From: "Catherine Naito" [REDACTED]
Sent: 30/09/2021 10:08 PM
To: "Council Northernbeaches Mailbox"
<Council.Northernbeaches@northernbeaches.nsw.gov.au>
Cc: "Naito, Kazuma" [REDACTED]
Subject: fao Rebecca Englund - planning - Application Number: REV2021/0034
Attachments: 229 WBR DA letter no. 2.docx

Re: DA 2020/0442 – Revised Development Application for DA2020/0442 submitted for Section 8.2 Review

I am writing on behalf of myself and my husband, the owners and occupiers of 229 Whale Beach Road, which adjoins the entire southern boundary of the site at 231 Whale Beach Road - the subject of the Revised Development Application for DA 2020/0442 (the "*Revised Application*"). This letter is a written submission objecting to the Revised Application.

The Original Proposal (above) and the Revised Proposal (below)

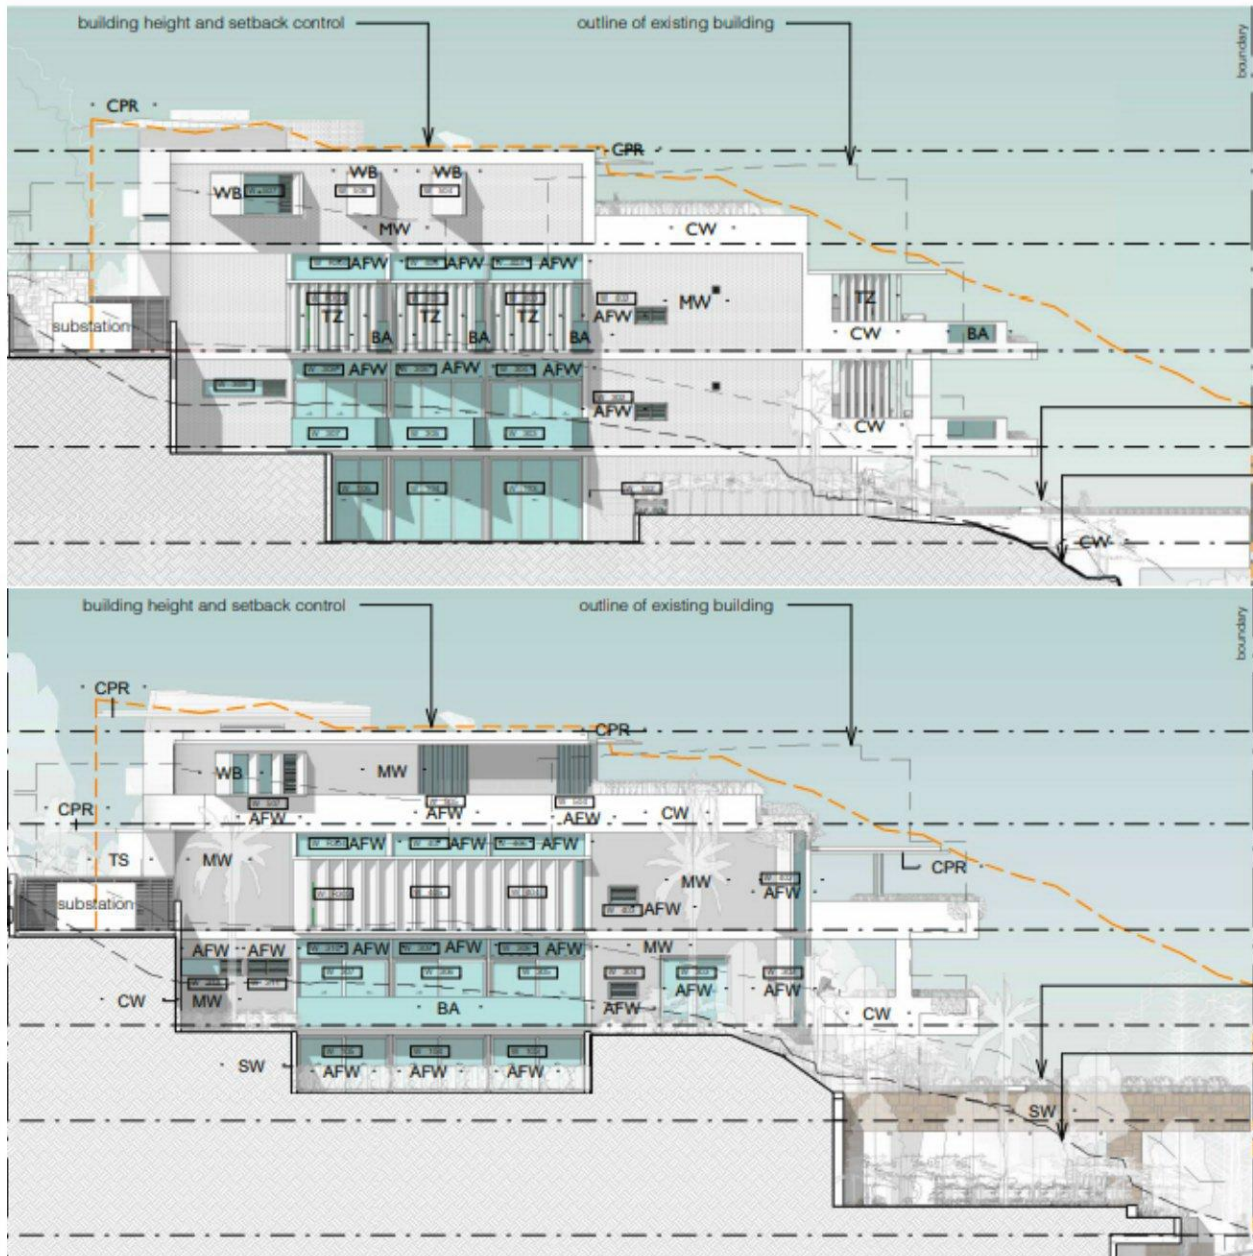
When the plans for the demolition and construction at 231 Whale Beach Road (the "*Original Proposal*") were submitted in May 2020, in a letter dated 4 June 2020 I set out our main reasons for objecting to the Original Proposal. The Original Proposal was refused and the Revised Application submitted, at which point we were dismayed to find that the building in the Revised Application is substantially the same as the Original Proposal and there has been no significant change to the bulk, scale, form and configuration and our concerns have not been addressed. The similarities are demonstrated by comparing the South Elevations – see below.

We will be faced with a sheer vertical wall over 4 floors of apartments and retail space hard against our entire boundary. This includes 9 double bedrooms, each with floor to ceiling double glass doors, living spaces each with multiple windows, a retail space with floor to ceiling glass doors, 4 large terraces, each with space to entertain 20 or more guests with barbecues directly overlooking us and in the case of the top floor, a spa. There is also a terrace on level one that will start only 80cm away from our boundary. Any one of these would have an extremely detrimental effect on our privacy, amenity and enjoyment of our house and garden and would cause a nuisance, both visual and acoustic, but the cumulative effect is completely unreasonable.

In addition, the south elevation (DA10) shows **nine** bedrooms, with floor-to-ceiling, wide windows and glass doors, that will now be hard against our border including an outdoor terrace area at level 1 that is less than 1m from our shared boundary. Again, no significant attempt has been made to reduce the impact of the development on our house, which is actually worse because we are now overlooked by more windows and doors, including a retail space.

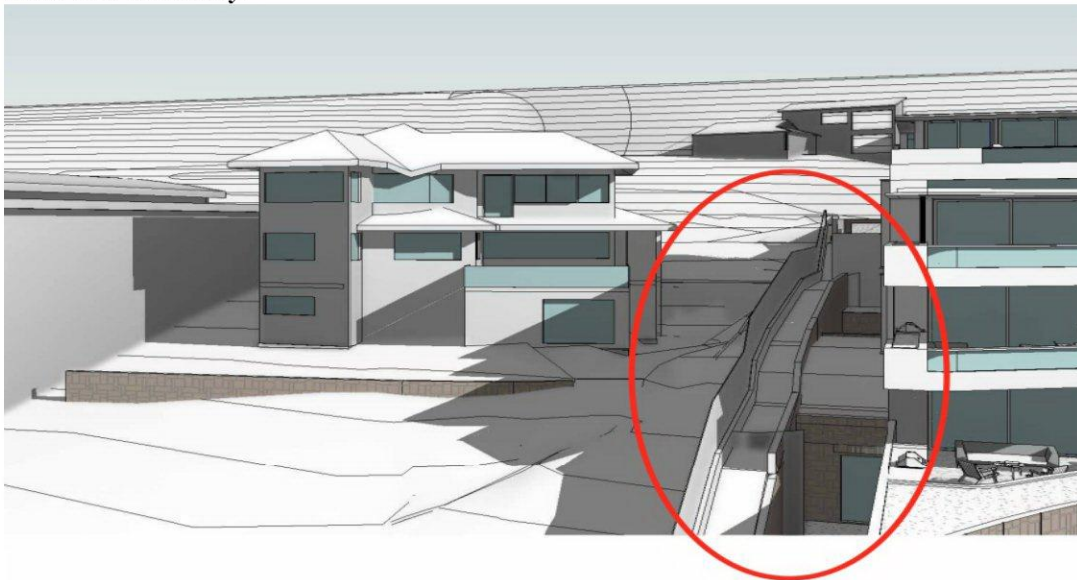
This image from the Revised Application highlights the 1.8m fence, the overland flow path, stone walls and other planned excavation works. While there may be a 4 metre setback in parts of the Southern elevation, the overland flow path and stone courtyards are only 1.1 metre away from our boundary.

The July 2021 AIA report notes the impact on our most important tree's Tree Protection Zone in order to facilitate a car park and stone courtyard. We reject the Applicant's view that the cost/benefit analysis to impact our tree to create more car park space is justified. The requirement for more carparking spaces is a result of trying to build something that is too big for the site, not the fault of the tree.

We would also respectfully ask the Council to challenge the viability and sustainability of any planting on our boundary, let alone planting that provides screening when the space has a 1.8m fence to the south, a 12m tall building to the north and is only 4m wide at its widest point but is less than 1m wide at the narrowest point. This is a critical point given the bulk and scale of this building in its current form. The ability to soften the shape and form of this southern elevation by planting is implausible. This is another reason why protecting the health of our tree at its current level is critical.
